Addendum No. 2

Project: Central Riverfront Leonor K. Sullivan Boulevard and Bikeway

Project Number: TDG-0705 (333) Project 2

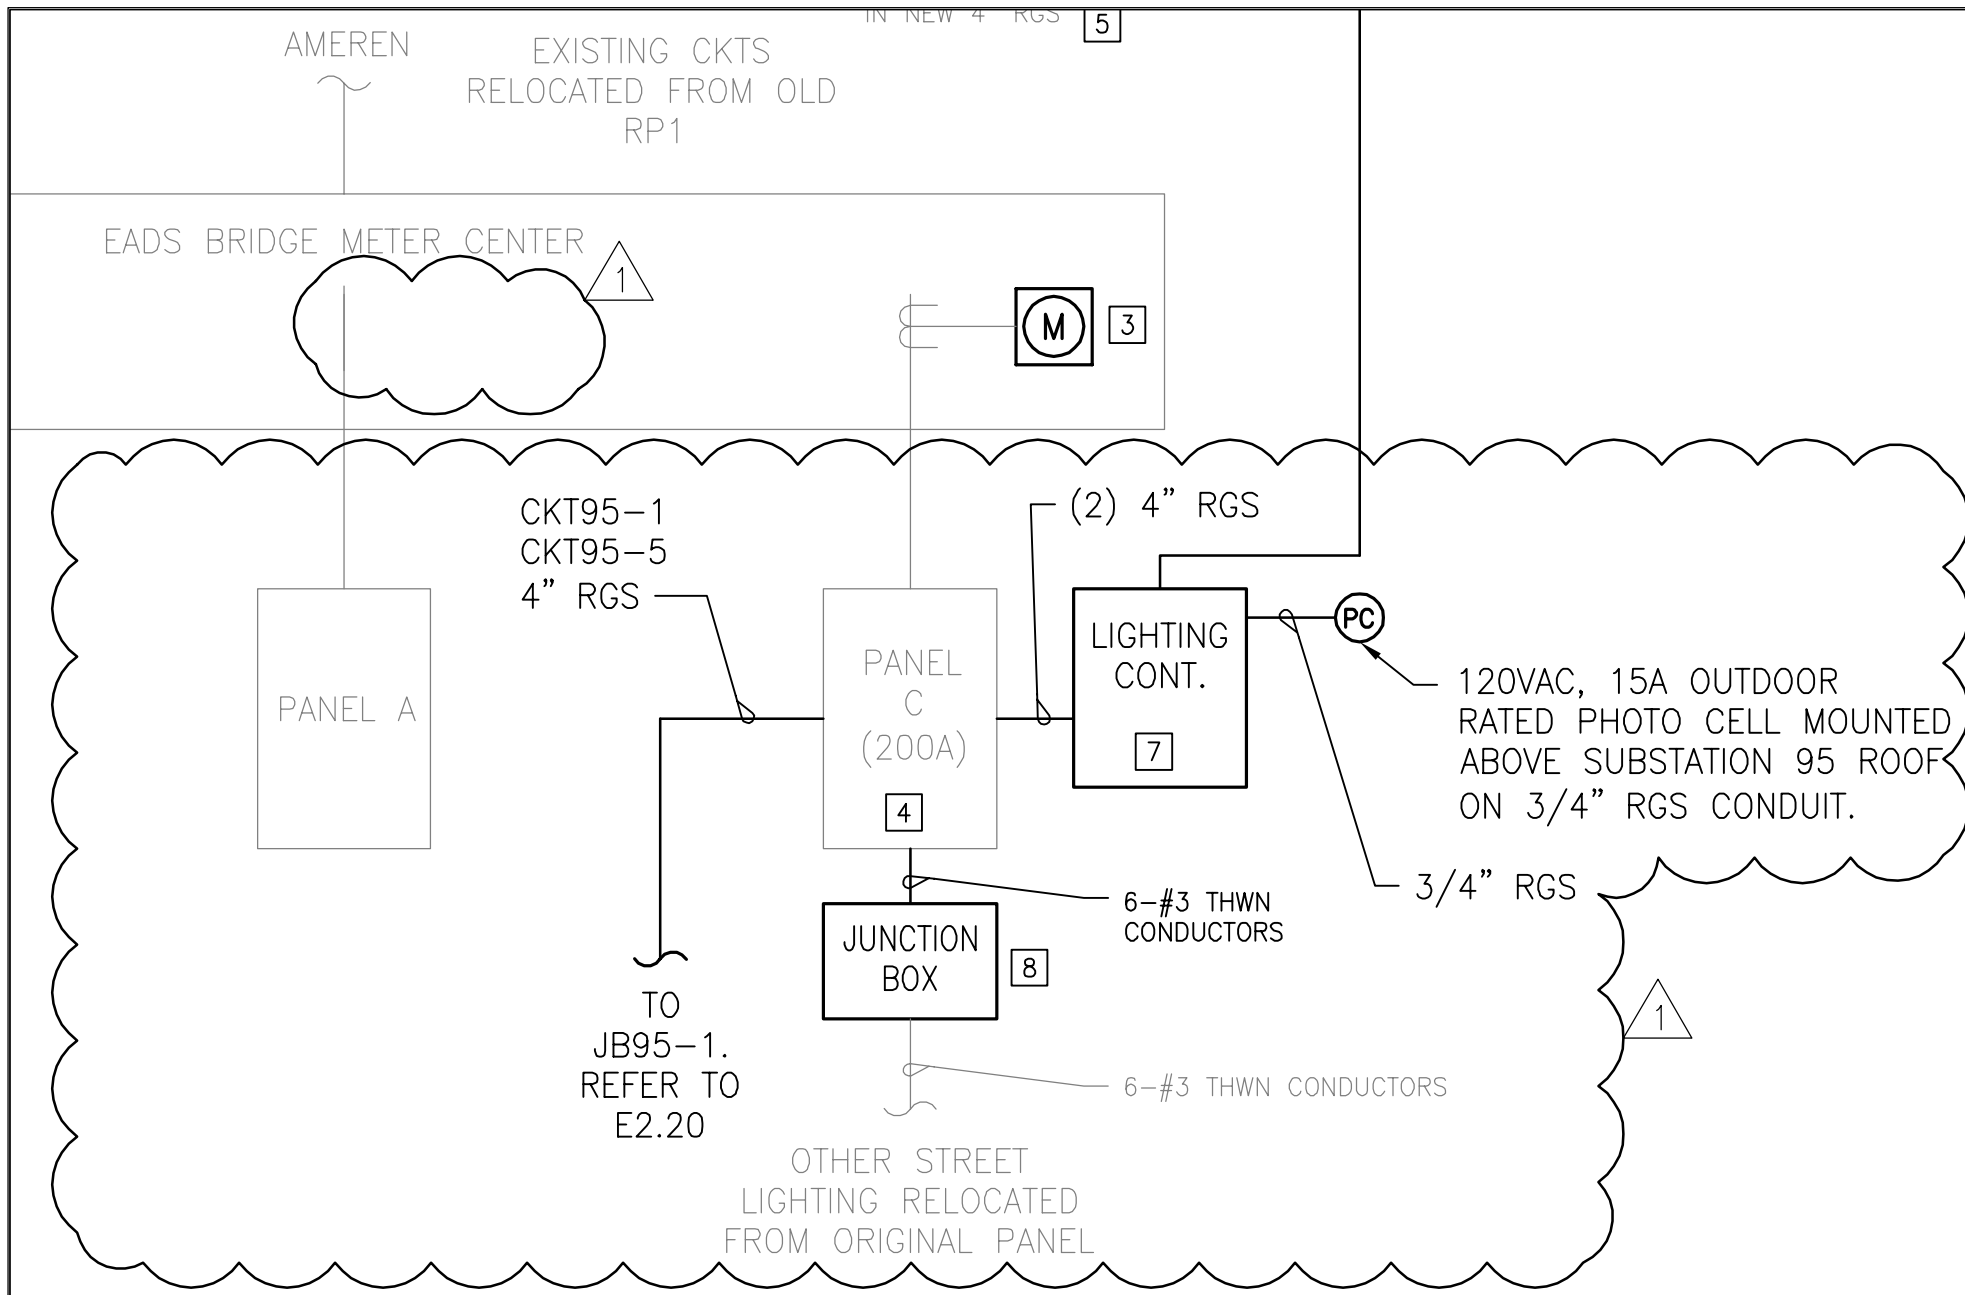
METER SOCKET. COORDINATE INSTALLATION WORK WITH AMEREN MO.
